**RE: Submittal of the Completion Review Report (CRR) for license termination of Source Material License WYSUA-0056 Western Nuclear Split Rock.**

**COMPLETION REVIEW REPORT**

License Number: WYSUA-0056

Facility: Western Nuclear, Inc. (WNI) Split Rock Uranium Mill Disposal Site

**Figure 1: Influence of groundwater velocity on time before ACL results in nitrate MCL at the POE**

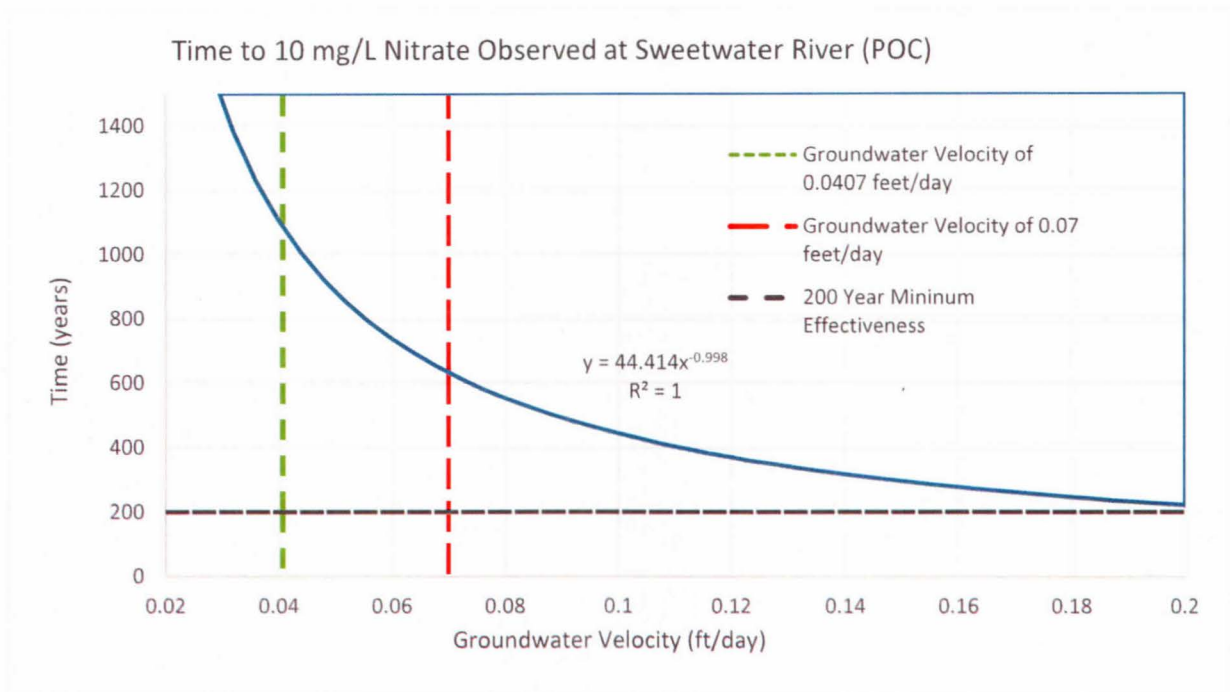
To estimate the sensitivity of the velocity parameter, the model was run numerous times using various groundwater velocity inputs. The fitted curve in Figure 1 corresponds with the results of those runs. The time where 10 mg/L of nitrate is observed at the POE in the model, the Sweetwater river, varies according to the relationship:

Assuming the lower end porosity estimated in the 1999 WNI Split Rock Groundwater Protection Plan (GWPP) (0.25) and the geometric mean hydraulic conductivity (7.36 feet/day), a velocity of 0.072 feet per day is calculated. Assuming these values, the time at which 10 mg/L may be observed at the POE would be 615 years. However, the best estimate of porosity is likely higher than 0.3, as observed in the laboratory testing completed in the 1999 GWPP, and as estimated by WNI (Aquifertek, 2016). This testing estimated porosities greater than 0.35, and the 1999 model was run using an estimate of 0.35. The hydraulic conductivity of 5 feet per day is based on model calibrations using pump tests and evaluating hydraulic head at the wells in the southwest valley. This estimate therefore is considered the best estimate of hydraulic conductivity. Thus, the velocity used in the ATRANS1 model is likely conservative.

Consistent with 10 CFR 40, Appendix A, Criterion 5B(6), the revised ACL of 500 mg/L for nitrate within the SW Valley would not appear to pose a substantial present or potential hazard to human health or the environment if not exceeded at the SW Valley POC well WN-21, or any point downgradient based upon the institutional controls in place from the tailings pile to the Sweetwater River. Therefore, this amendment to increase the nitrate ACL in the SW valley from 70.7 mg/L to 500 mg/L is approved.

FIGURE 1  
SITE OWNERSHIP MAP

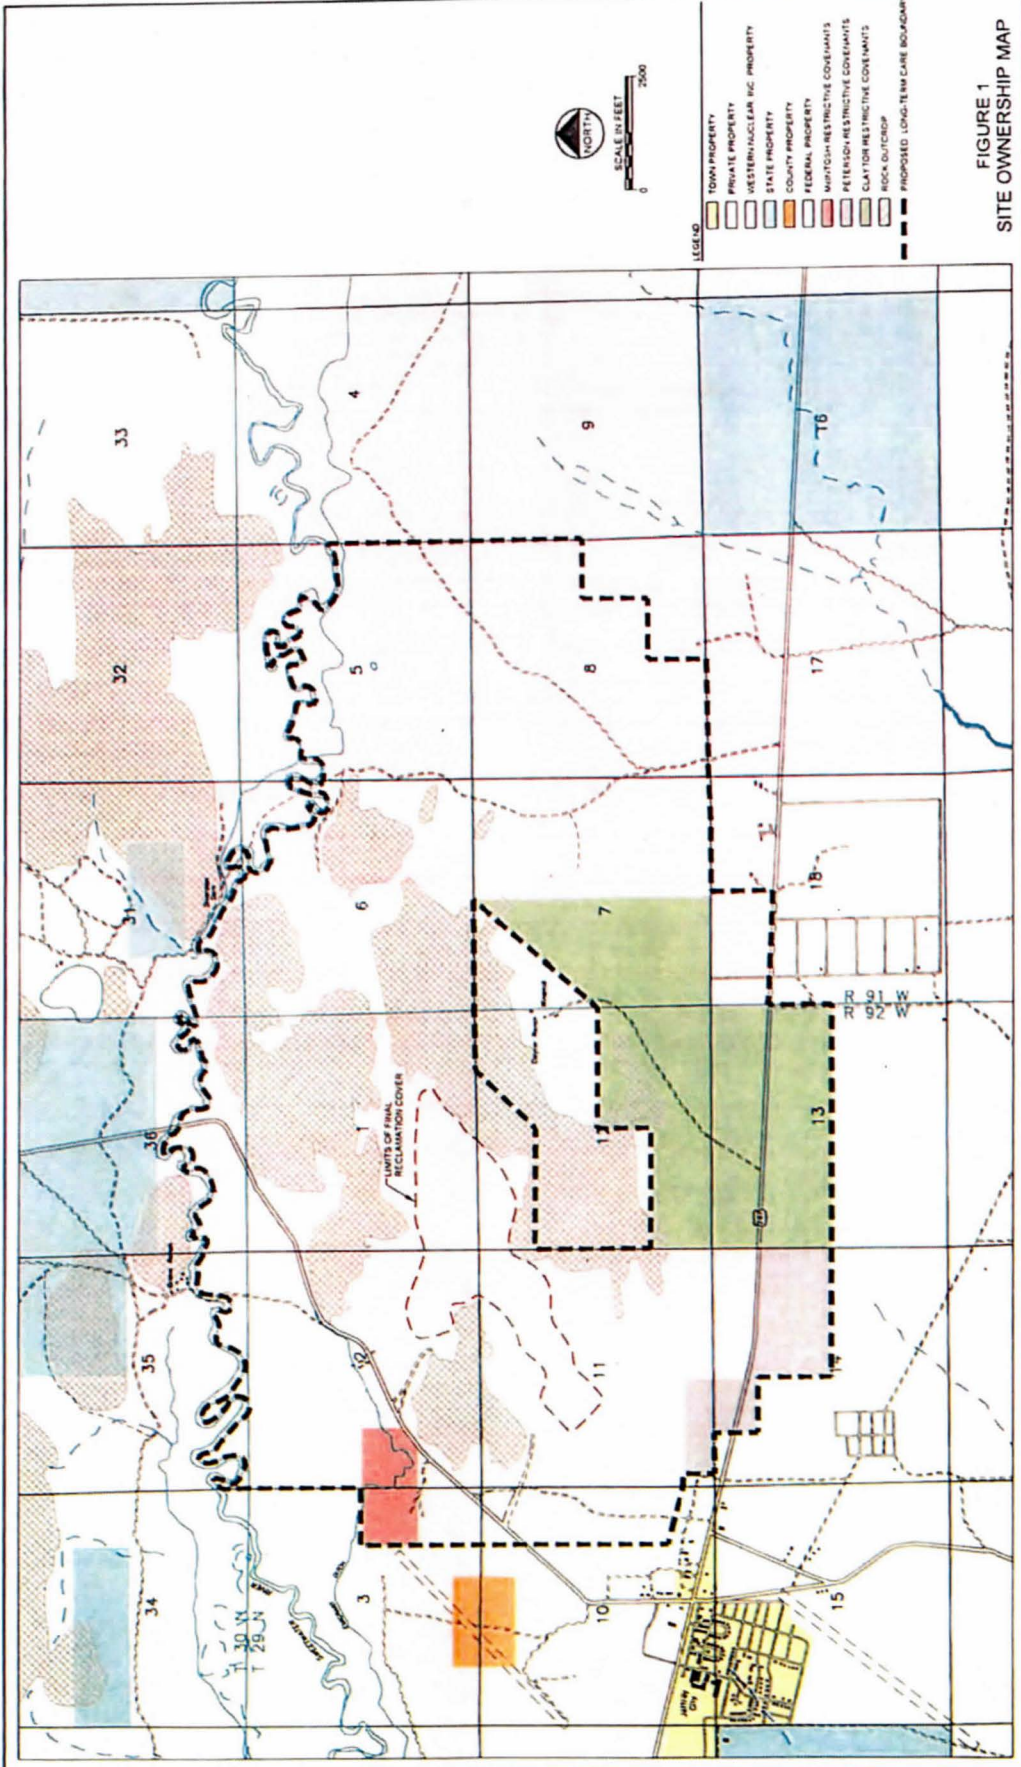
Additionally WNI has requested to extend the LTSB to encompass additional lands from those currently approved as presented in a WNI letter to the LQD dated January 11, 2019. This extension provides for the revised SW Valley nitrate ACL such that the nitrate plume exists in isolation. WNI or the federal government owns a majority of the land within the proposed extended LTSB. The small portion of land not owned by WNI or the federal government has durable administrative land use restrictions, acquired by WNI, to disallow water well drilling. This effectively prevents exposures of humans, livestock, or wildlife to potentially contaminated groundwater.

As stated in 10 CFR 40.28(b), “the general license in paragraph (a) of this section [for the Department of Energy’s Long-Term Surveillance and Maintenance] becomes effective when the Commission terminates, or concurs in an Agreement State’s termination of, the specific license and the site Long-Term Surveillance Plan (LTSP) meeting the requirements of this section has been accepted by the Commission.” The DOE is required to submit the LTSP to the NRC which will include both a proposed long-term environmental monitoring program and the proposed LTSP as discussed in 10 CFR 40.28(1), (2), and (3). Upon review and approval of the LTSP, the LTSP and long-term monitoring program, pursuant to the general license in 10 CFR 40.28 becomes effective. While the groundwater monitoring wells proposed by WNI for the SW Valley would be considered protective for near-term monitoring in comparison to the 1000 year compliance period, the prolonged transport times for constituents to reach the LTSP reduce their effectiveness for determining potential health and safety impacts at the POE. Thus, groundwater monitoring may not be necessary in the SW Valley following license termination due to the proposed LTSP expansion, with potentially only surface water samples needing to be collected at the proposed Sweetwater River sampling points. Therefore, the LTSP extension as presented in addendum 1 and WNI's January 11<sup>th</sup>, 2019 letter to the LQD is also approved.
